THE BLUFFS AT CYPRESS CREEK **SUBDIVISION, PHASE ONE**

APPLICATION NUMBER 14 DATE March 19, 2009

DETAIL SITE PLAN

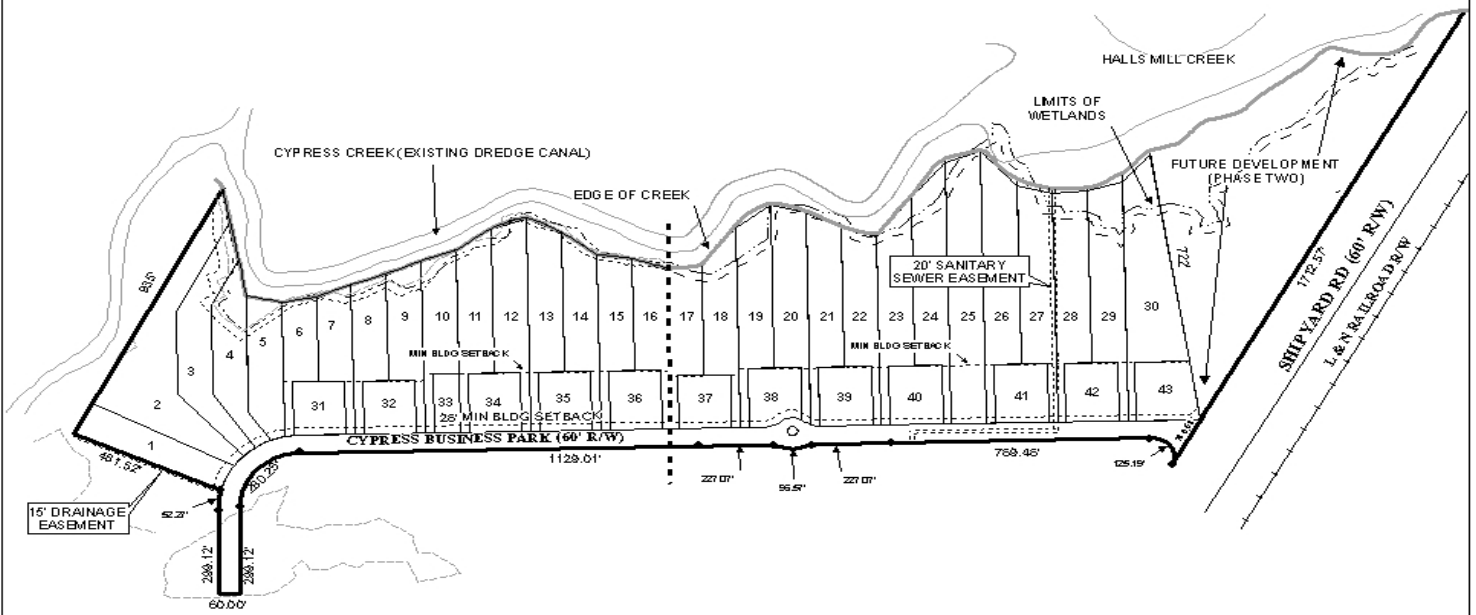
The applicant should revise the 25-foot minimum building setback to illustrate the 25-foot within the lots that are flag-shaped.

The applicant should be aware that flag-pole shaped lots such as several of the proposed lots are unconventional in design; however, as the site is located along a waterway, and in an area of heavy commercial zoning this type of lot design is often used in industrial developments; therefore, the waiver of Section V.D.3. would be required.

As a means of access management, the placement of a note on the Final Plat stating that lots 1-6, 11, 24-26 and 31-43 are limited to one curb-cut, and lots 7 & 8, 9 & 10, 12 & 13, 14 & 15, 16 & 17, 18 & 19, 20 & 21, 22 & 23, 27 & 28 and 29 & 30 are limited to a shared curb-cut along their common interior lot lines, with the size, design and location to be approved by Traffic Engineering and conform to ASHTO standards.

- 1) the revision of the 25-foot minimum building setback to reflect 25-foot within the actual buildable area;
- 2) the placement of a note on the Final Plat stating that lots 1-6, 11, 24-26 and 31-43 are limited to one curb-cut, and lots 7 & 8, 9 & 10, 12 & 13, 14 & 15, 16 & 17, 18 & 19, 20 & 21, 22 & 23, 27 & 28 and 29 & 30 are limited to a shared curb-cut along their common interior lot lines, with the size, design and location to be approved by Traffic Engineering and conform to ASHTO standards;
